RE: Response to Request for Supplemental Information on Make Up Water Pumping Station
Culclasure Farm Tract, LLC
Proposed Culclasure Farm Mine, Mine Permit Appl I-002093

CULCLASURE FARM TRACT LLC
CULCLASURE FARM MINE
 MINE PERMIT APPLICATION I-002093
 CALHOUN COUNTY, SC

INITIAL INFRASTRUCTURE DEVELOPMENT

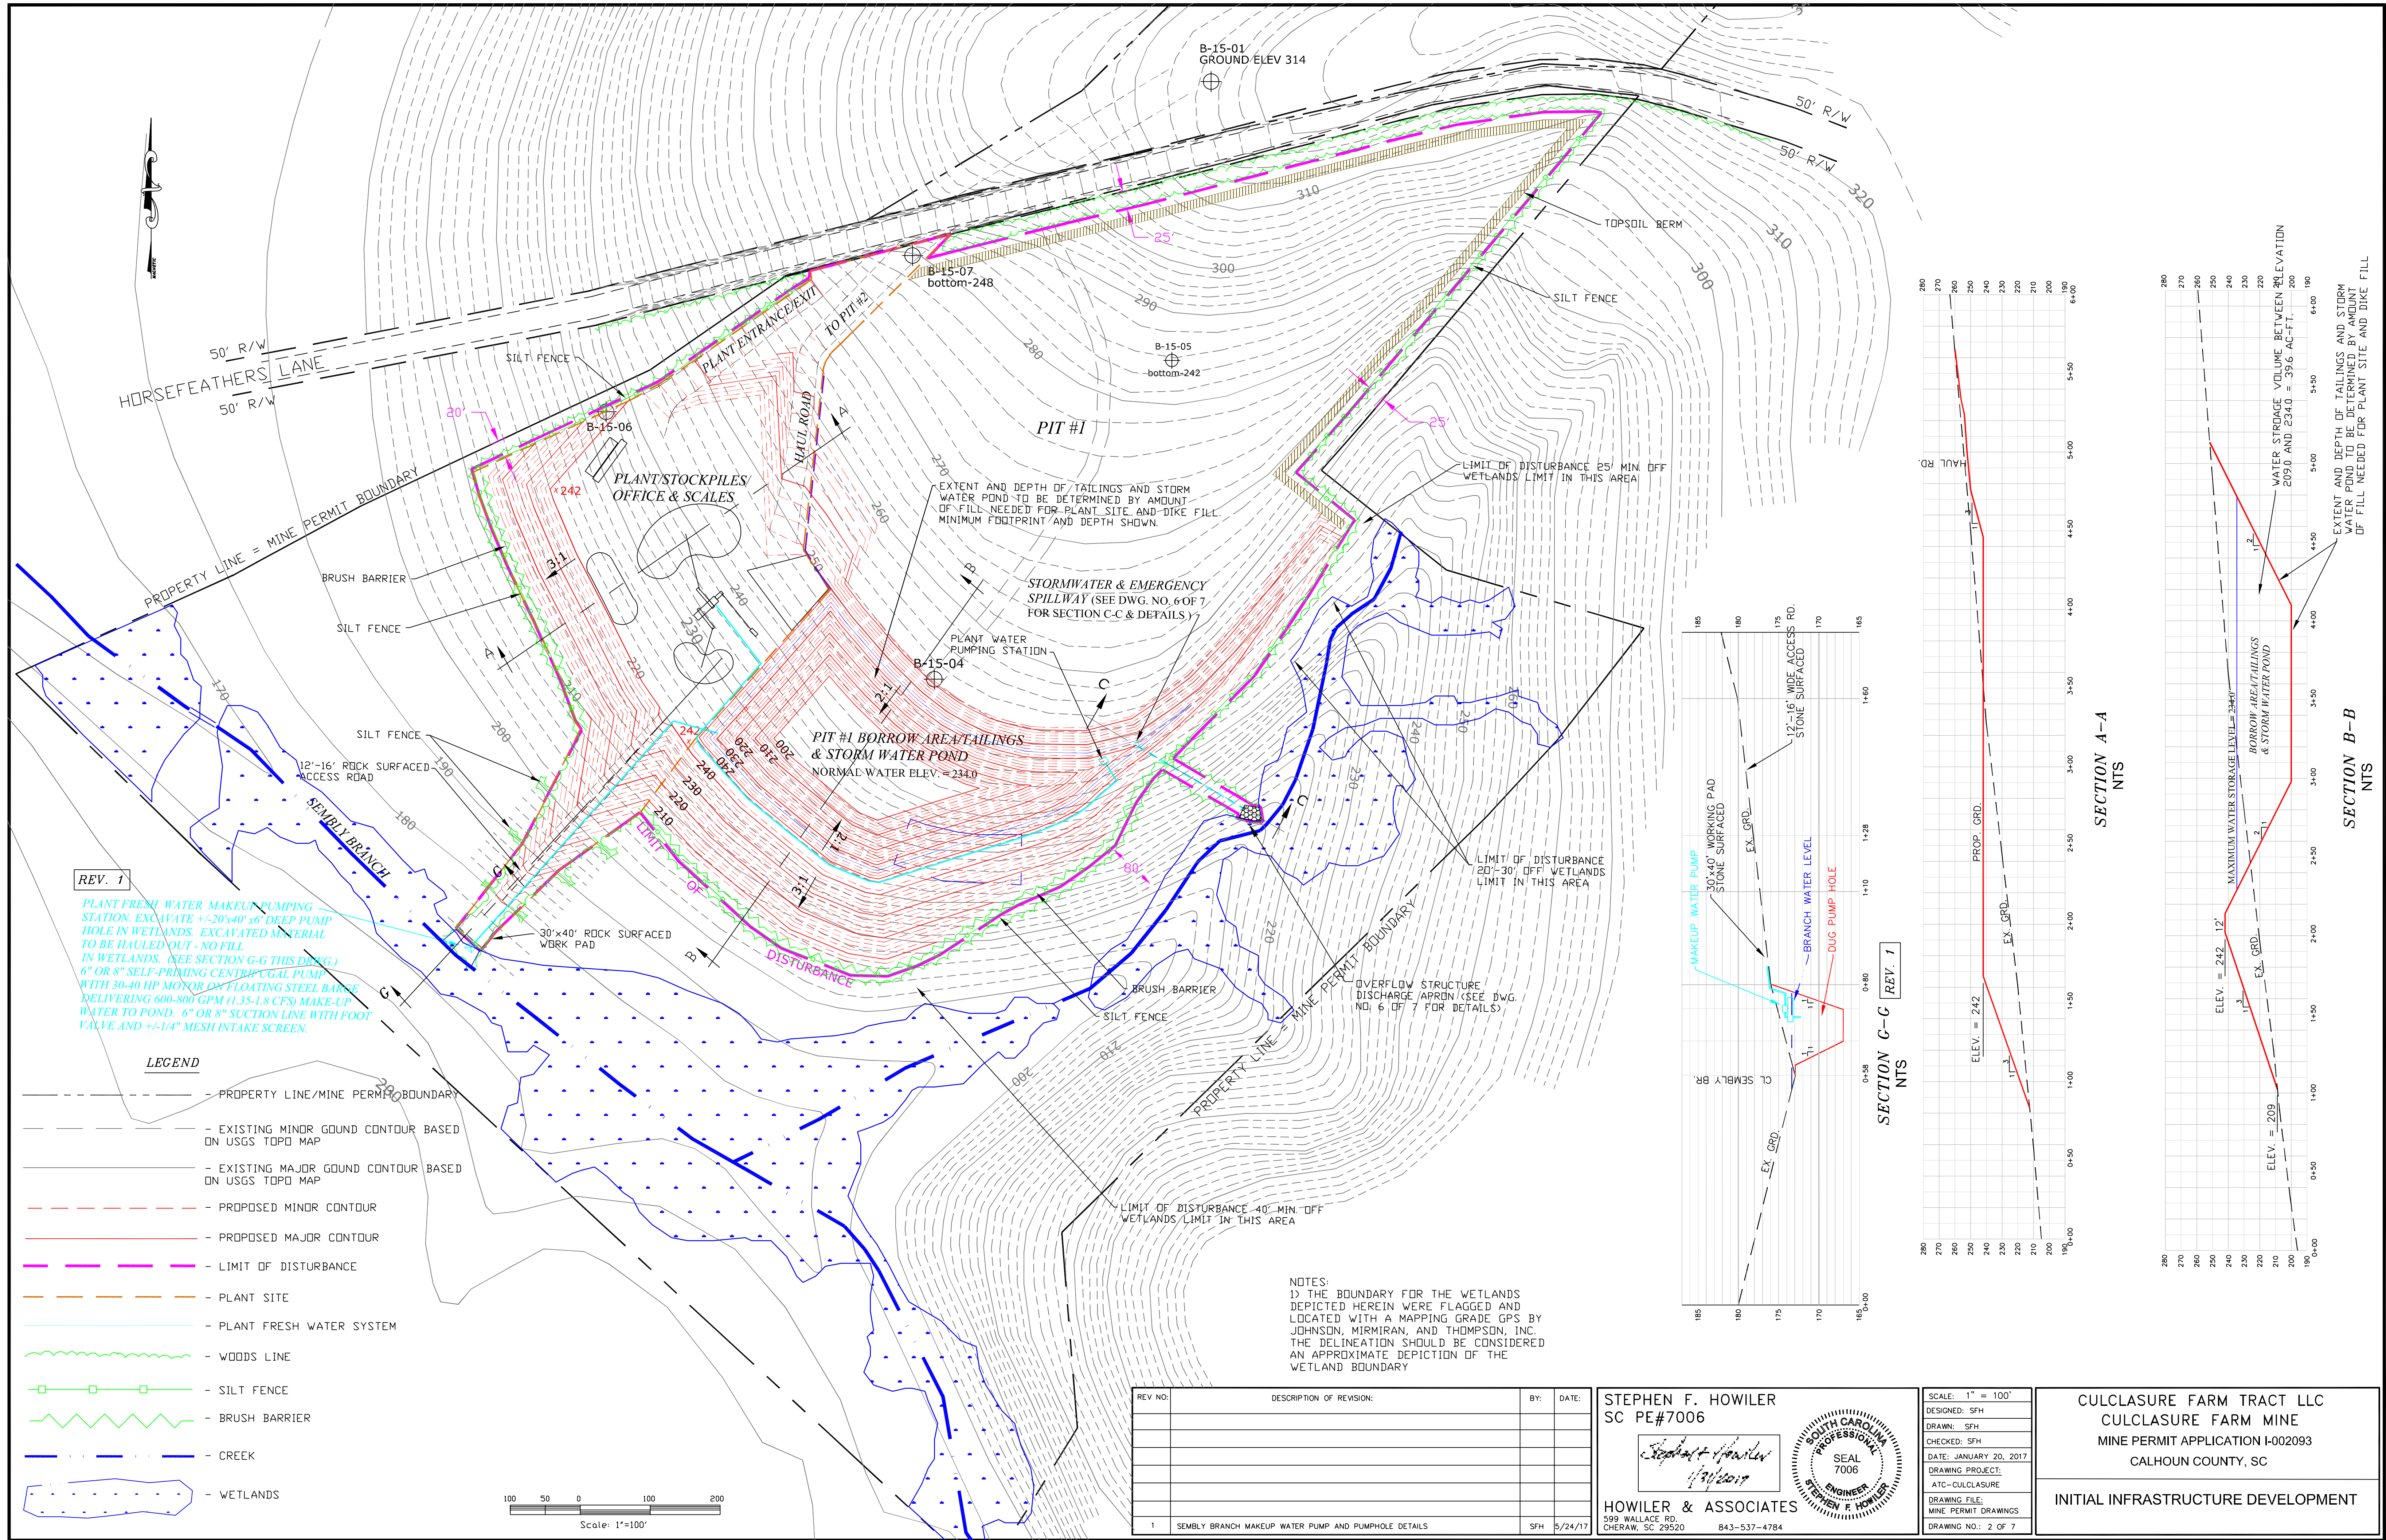
Please find below and attached supplemental information requested in your May 22, 2017 email. As developed by Howiler and Associates, attached is a revised *Initial Infrastructure Development Map* (DWG No. 2 of 7, revised 5/24/17) showing the information requested. The below information is a synopsis of the information on the revised drawing.

Excavate approximately 20'x40'x6' deep pump hole in wetlands. The excavate material to be hauled out with no fill to be placed in wetlands. (See Section G-G' on DWG NO. 2 of 7 rev 5/24/17). A 6" or 8' self-priming centrifugal pump with 30-40 hp motor on floating steel barge delivering 600-800 GMP (1.35 -- 1.8 CFS) will be used to supply water to make-up water pond. The pump will use a 6" or 8" suction line with foot valve and +/- 1/4" mesh in-take screen.

As shown on the drawing, the Pit #1 tailings/stormwater pond will store the make-up water. To provide enough water to operate it will take several months pumping up to, but no more than 3,000,000 gallons/month from the pump hole. Also during this time, stormwater will be diverted to the pond for storage. Once the pond reaches maximum capacity and sand washing operations begin, the need to pump and store water from the pump hole is estimated to be 5 - 10 hours per week.

PLANT FRESH WATER MAKEUP PUMPING STATION. EXCAVATE ~6'20"x40"x6' DEEP PUMP HOLE IN WETLANDS. EXCAVATED MATERIAL TO BE HAULED OUT - NO FILL IN WETLANDS. (SEE SECTION G-G THIS DRAWING) 6" OR 8" SELF-PRIMING CENTRIFUGAL PUMP WITH 30-40 HP MOTOR ON FLOATING STEEL BARGE DELIVERING 600-800 GPM (1.35-1.8 CFS) MAKE-UP WATER TO POND. 6" OR 8" SUCTION LINE WITH FOOT VALVE AND 1/4" MESH INTAKE SCREEN.
